## City of Sugar Hill Planning Staff Report VAR 17-004

**SUBJECT:** Variance Request VAR 17-004 | Stream Buffer Variance

The City of Sugar Hill received an application dated May 3, 2017 from Home South Communities requesting relief from the 75-foot impervious stream buffer under the Stream Buffer Protection Ordinance to construct a new single family home at 885 Grove Glen Court.

Variance Case VAR 17-004 Applicant: Home South Communities, LLC

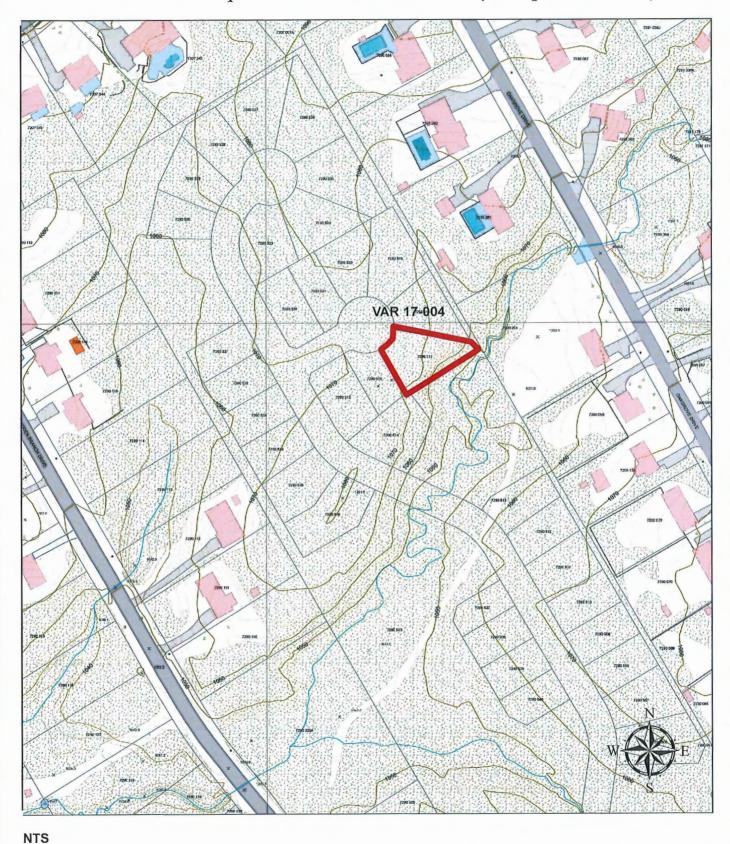
The house and patio will encroach approximately 20 feet into the 75-foot impervious surface area buffer.

## Whether alternative designs are possible which require less intrusion or no intrusion; The developer has indicated that the smallest house plan is being used in order to minimize the

intrusion. However, it appears that the minimum dwelling sizes could still be met without impacting the stream buffer.

The applicant did not provide a study, but the impact associated with this request is expected to be minimal. However, the cumulative impact of variances such as this will disrupt the integrity of the stream corridor and potentially impact water quality by reducing the groundwater recharge area.

Issuance of the variance would not help to protect natural resources. Rather, it could contribute to erosion and reduce the tree canopy, among other impacts.

No mitigation activities have been identified.

Approval provided on-site mitigation efforts successfully compensate for the loss in stream buffer protection area.
